Port Hardy CCG SAR – Float Replacement Addendum #2

The following changes / clarifications in the tender documents are effective immediately. This Addendum will form part of the Contract Documents.

ANODE INSTALLATION INSTRUCTIONS

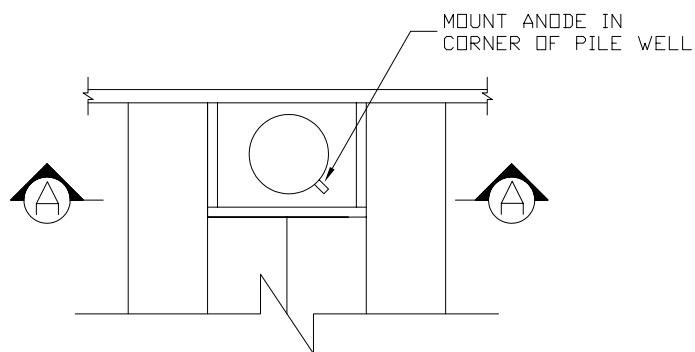
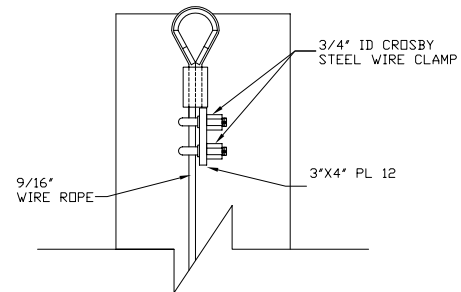
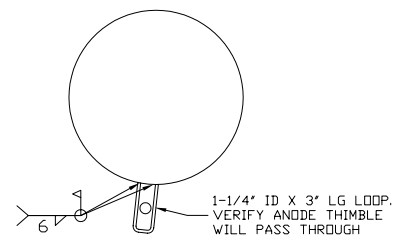
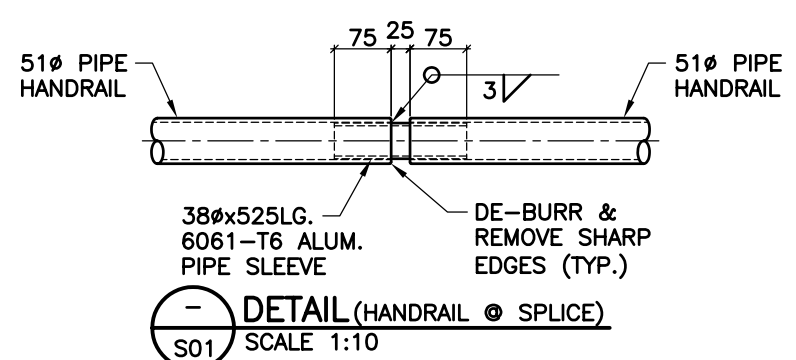
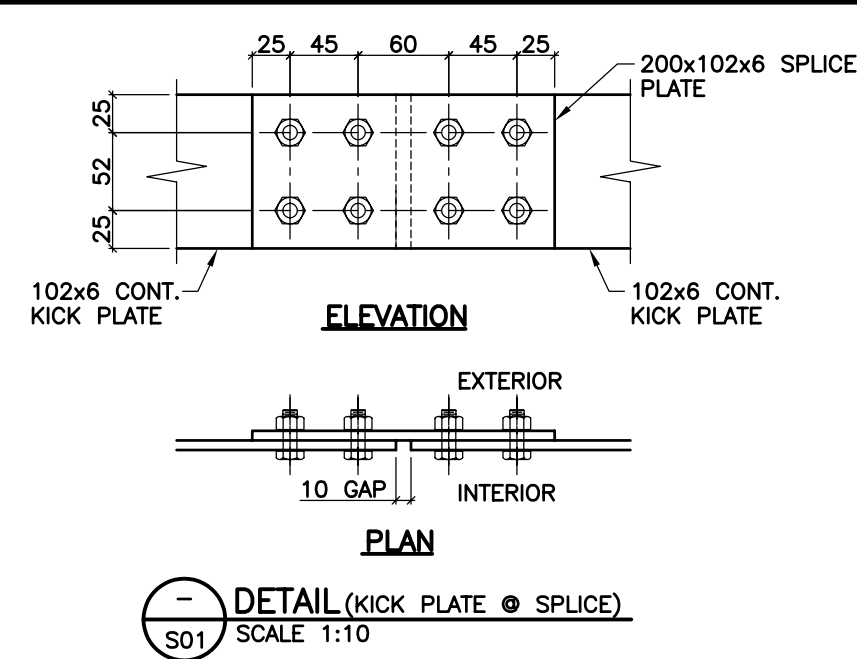
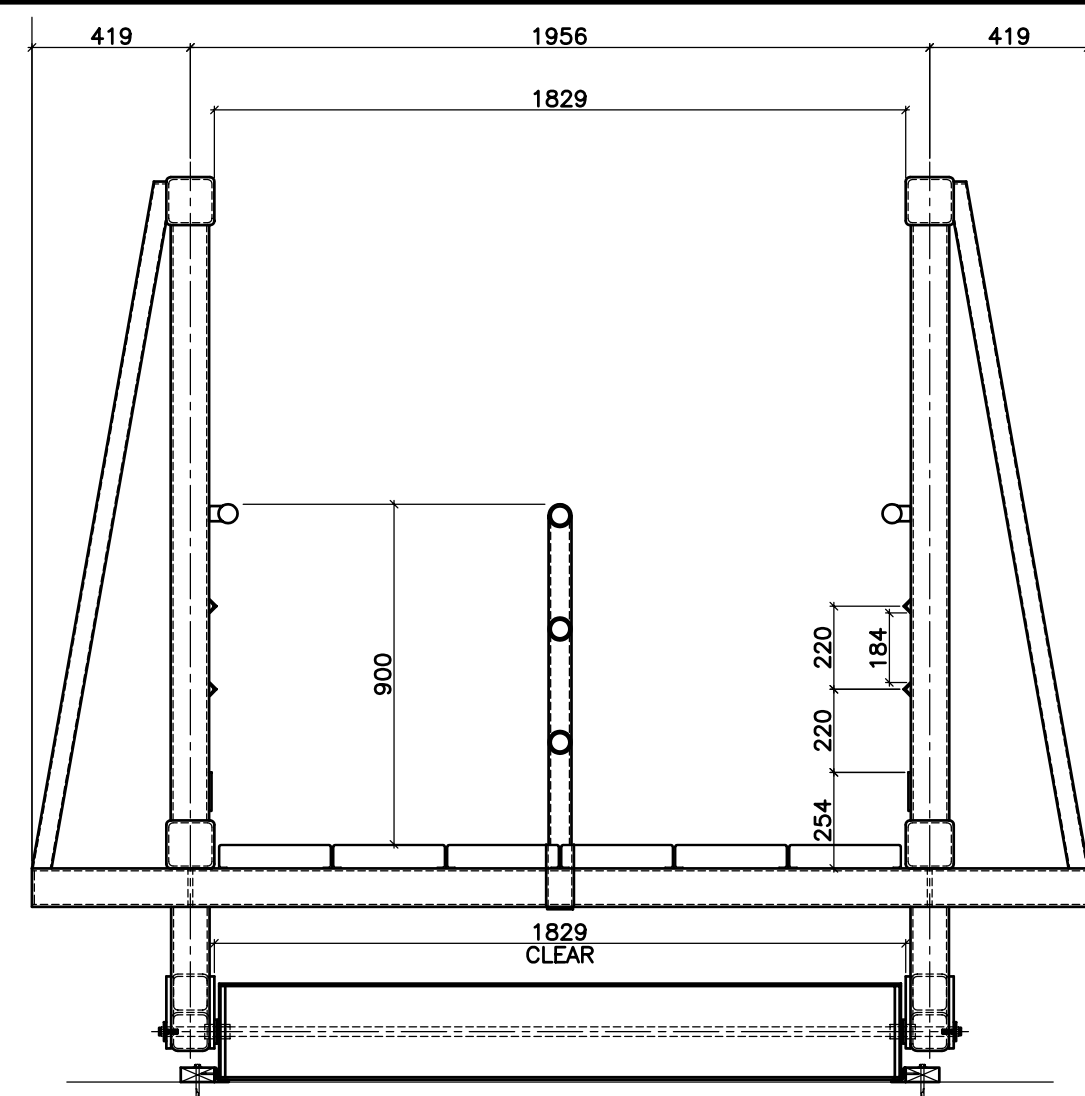
2. Can you please provide the procedure for the installation of the owner supplied anodes?

See Amendment #1 below for reference drawing "Anode Installation Instruction". Note that anodes will come with Crosby clamps, and mounting plate to be welded to pile; the cable loop as identified in detail 2 will not be required.

**ELECTRICAL TRANSFORMER
RECEPTACLE CABINET DETAILS**

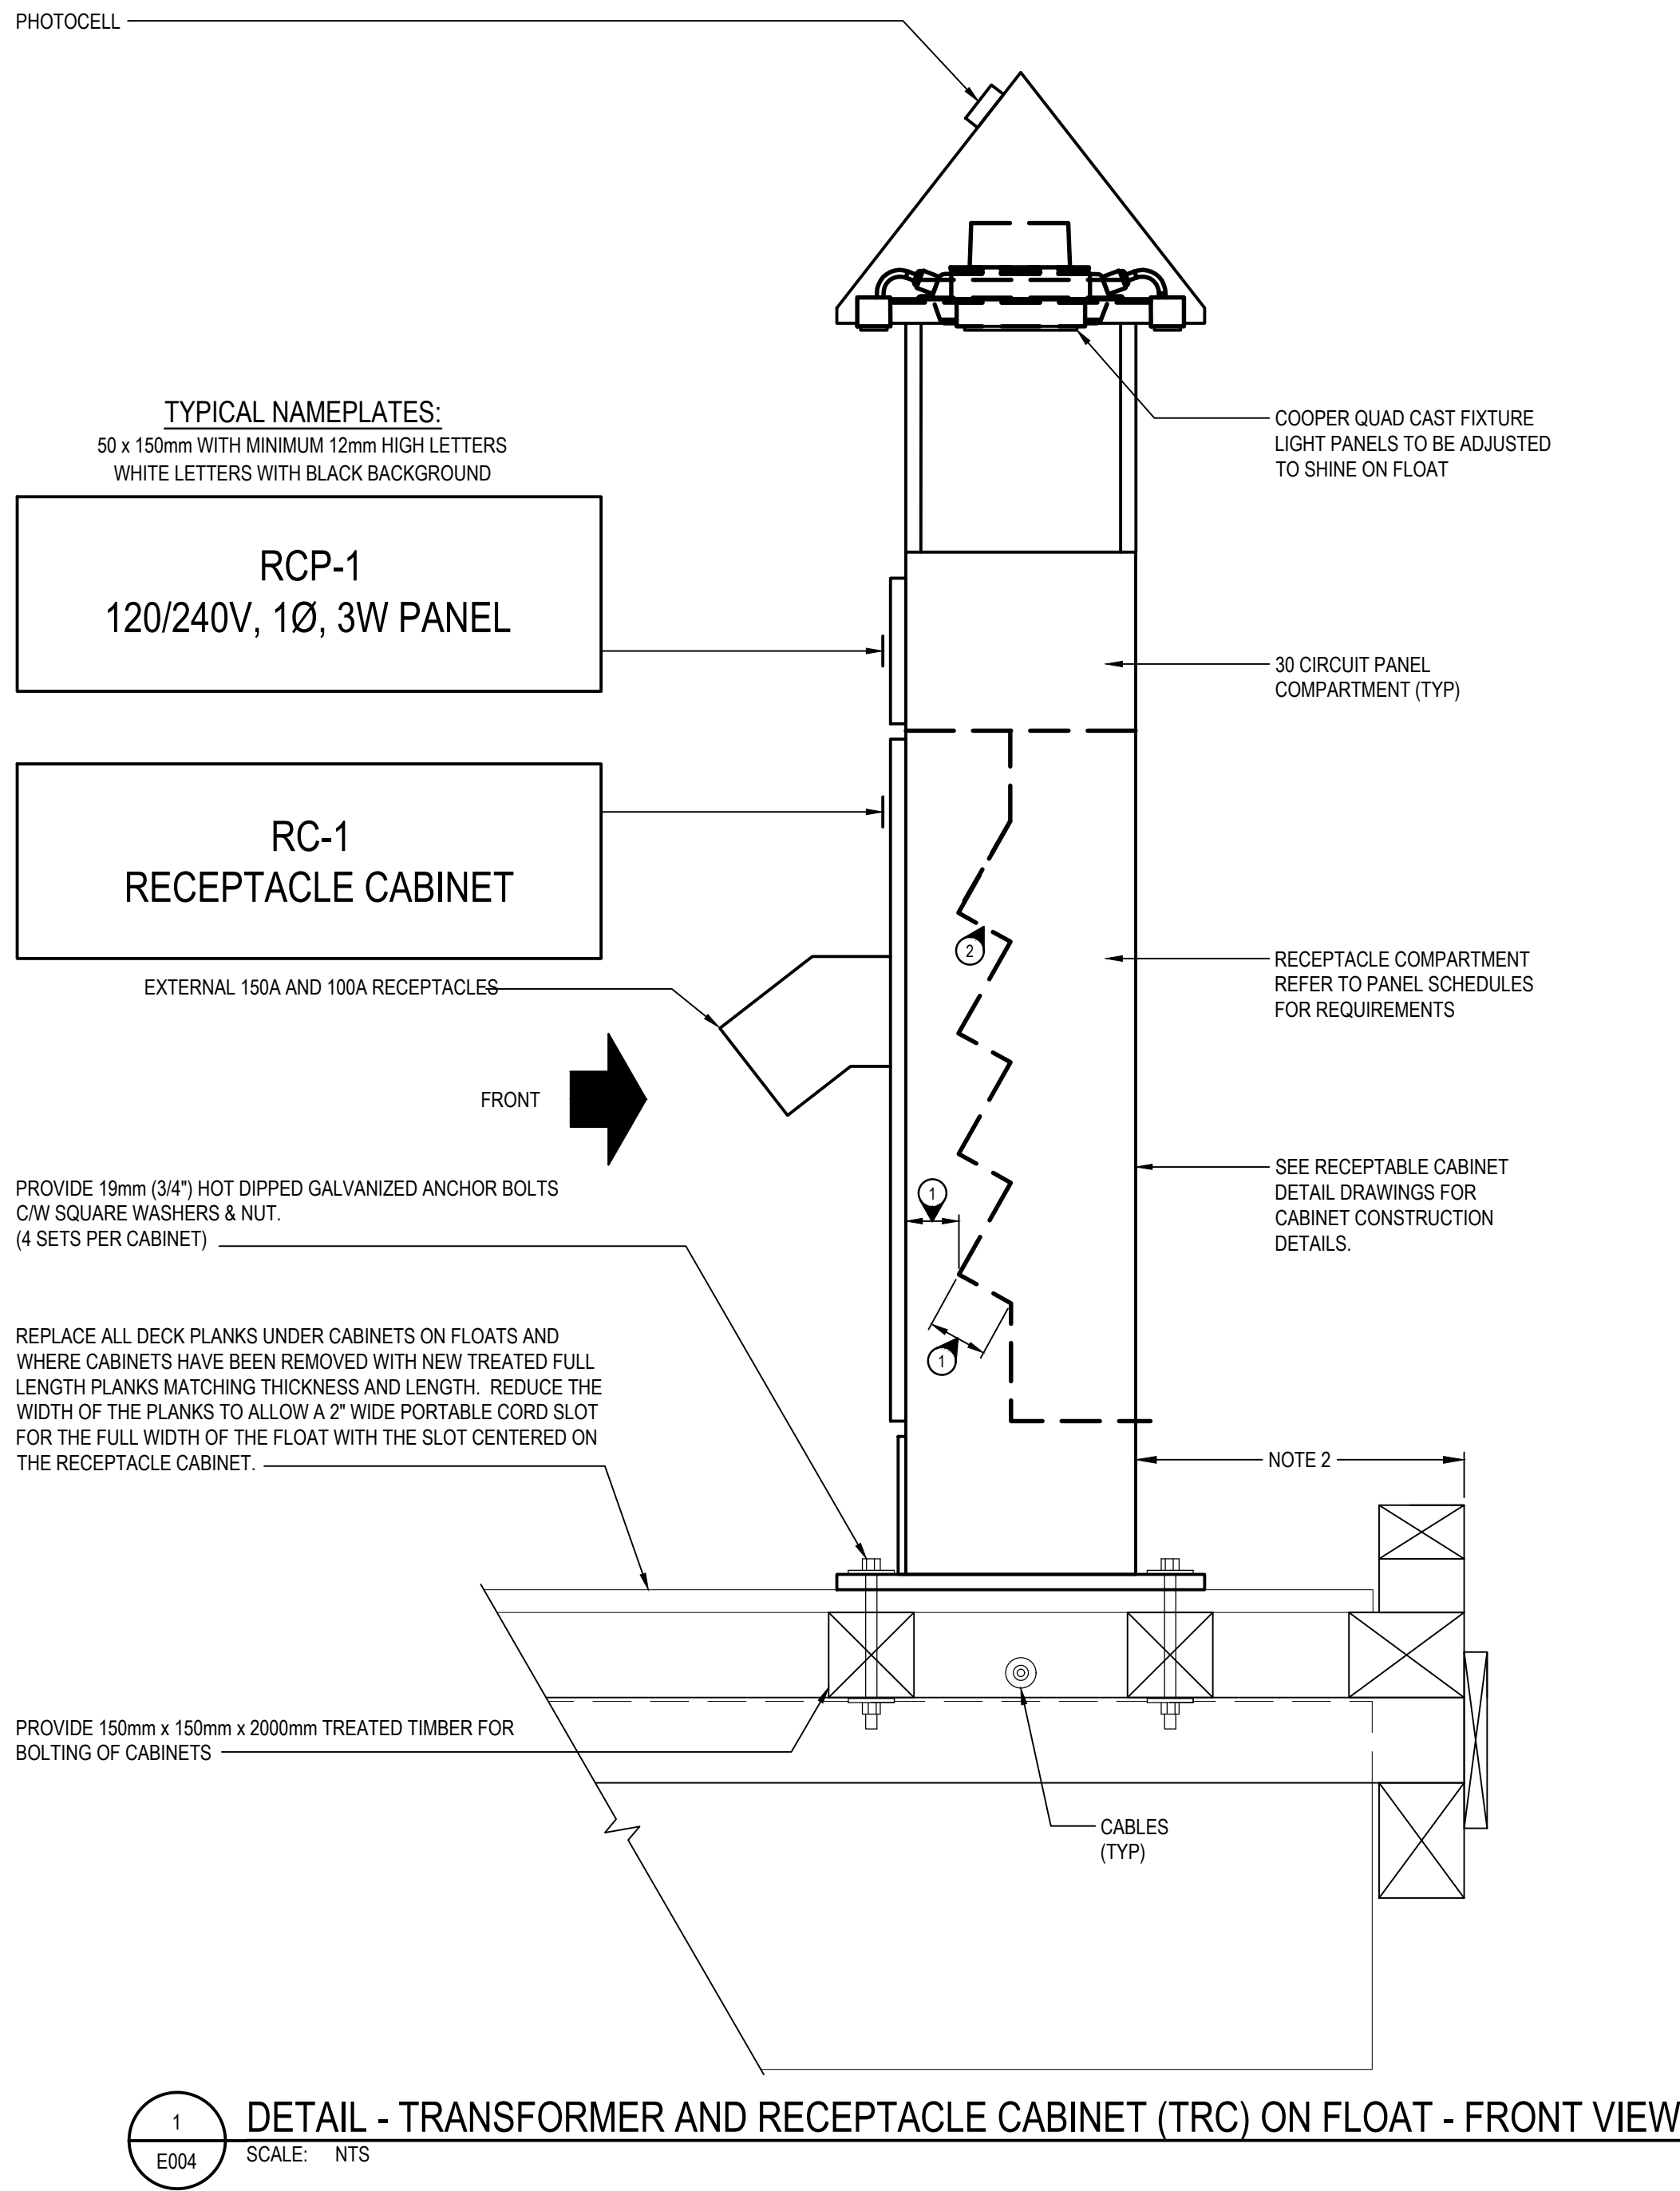
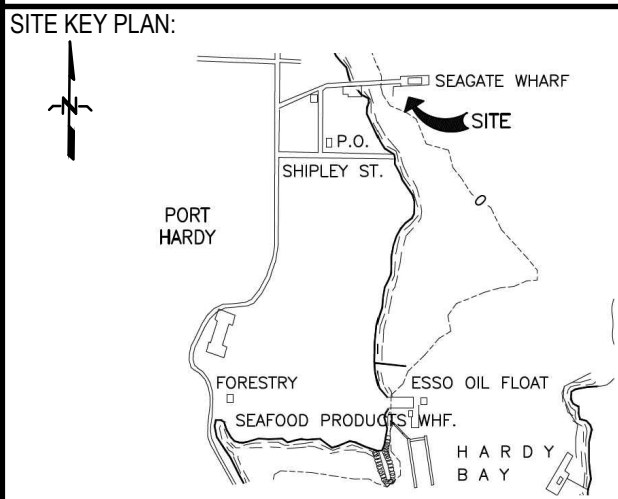
4. The 75kVA 1PH 600-120/240V epoxy potted transformer is not available according to the manufacturer. The largest available in this configuration is only 50kVA. Please provide further clarification.

- 1. Last year the largest panel in these kiosks was 225A 42 circuit main lug panel. The 400A 30 circuit main breaker panel shown is 12" taller. Allowing for bending space for wires we don't have that extra 12" available in this size of kiosk.**
- 2. To accommodate a 100A 1P breaker rated to 22kA we would need even more space to accommodate a sub-feed kit.**
- 3. Only the 20A receptacles are shown as GFCI protected on the drawings. In order to accommodate for GFI protection for the 100A 1P circuit, we would need to install a GFI relay (max 1 pole GFCI breaker is 30A) requiring even more space. In order to**

accommodate these changes, we would need to add as least 24" to the height (currently 119" tall) or width (currently 43" wide) or a bit of both.

Please confirm if dimension changes are acceptable as noted.

After consulting several manufacturers, a 75kVA 1ph 600-120/240V transformer is not available. As a substitute, the contractor shall install a 75kVA 1ph 600-120/240V dry-type transformer in the existing electrical room and provide increased cable size from the transformer to a new receptacle cabinet on the trestle. See Amendment #3 and #4 for revised drawings.

Applies to all three questions*: dimensions are acceptable as noted. Please coordinate the final location and sizes with the float contractor once final dimensions are available. Although both height and width can be added to the cabinets as required to fit the new equipment, an increase in height would be preferable where possible, provided all receptacles are still at an accessible height.
